Edition / Year,Month	1 / 2304	2 /	3 /	4 /	5 /	6 /
Material	45+硬质合金	Drawn	Checked	Approv.	Scale	1:2
Mass	0,64 kg	CX	CZ	JL	Date	2023.04.21
First Angle Projection	Product Name			Drawing No.		Version
	前油石导板			MT_04_23024_0_806		V1

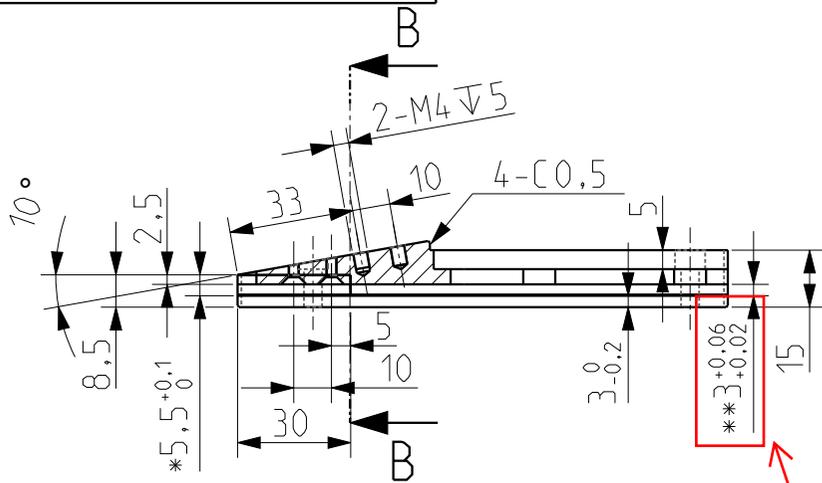
改成17.5

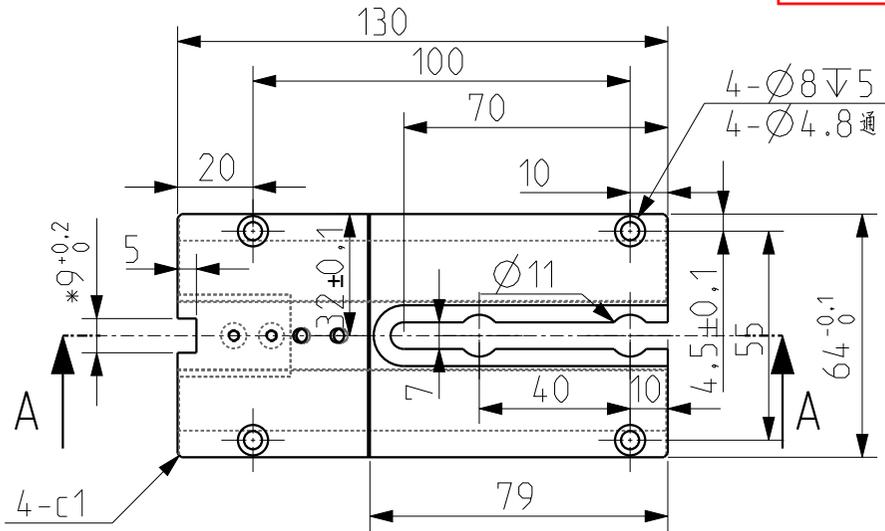
改成4

标识零件编号
及供应商简称
